Rear Engine Cover Not Installed (TI 60/19)

Vehicle Type: **Panamera GTS (971)/Panamera GTS Sport Turismo (971)
Panamera Turbo (971)/Panamera Turbo Executive (971)/
Panamera Turbo Sport Turismo (971)
Panamera Turbo S E-Hybrid (971)/Panamera Turbo S E-Hybrid Executive (971)/
Panamera Turbo S E-Hybrid Executive (971)**

Subject: **Rear engine design cover**

Engine design cover

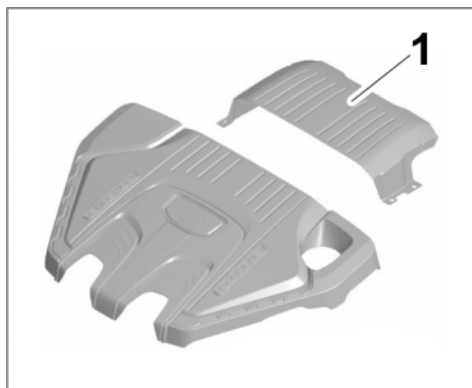
Information: **Since week 18/2019, the rear section of the engine design cover is no longer installed during production.**

- 1** – Engine design cover, **rear** (no longer installed)

On vehicles without the rear engine design cover, this cover does not have to be retrofitted during the sales check and **must not be invoiced as a missing part using a warranty claim.**
